SUBJ: **Clarifications to the Specifications and Responses to Vendor's Questions**

BID ITEM: **Bid Item 20-282 Construction Services for Friedman Branch Library Renovations for the Central Services Department – Facilities Maintenance Division**

ADDENDUM 1

A1-1 HALF WALL SECTION

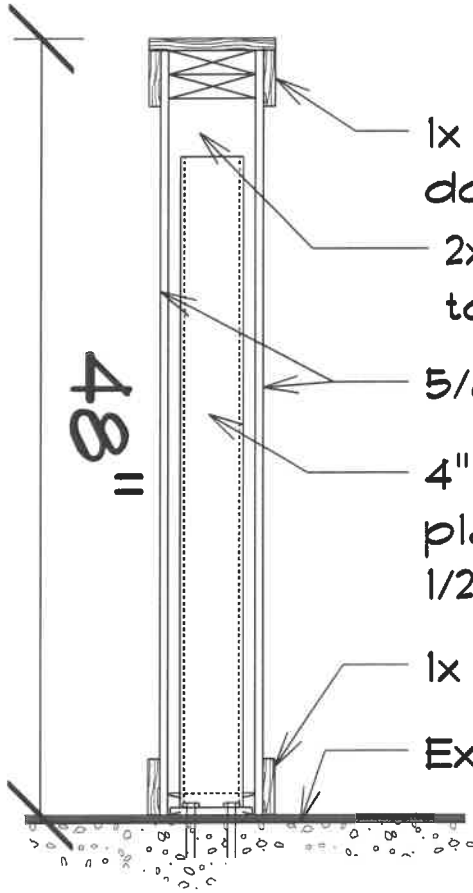
a. No Wall Detail for the half walls to be built, what is the wall to be made off?

Answer: See Sketch A1-1 (attached to this Addendum 1).

1x Trim - Paint to match door frames

2x6 @ 6" OC, attach securely to TS post.

5/8" GWB, painted

4" TS Post, 42" high, w/3/8" base plate, anchor to floor with (4) 1/2" x 4" anchors. Space at 48" O.C.

1x base, - paint to match base
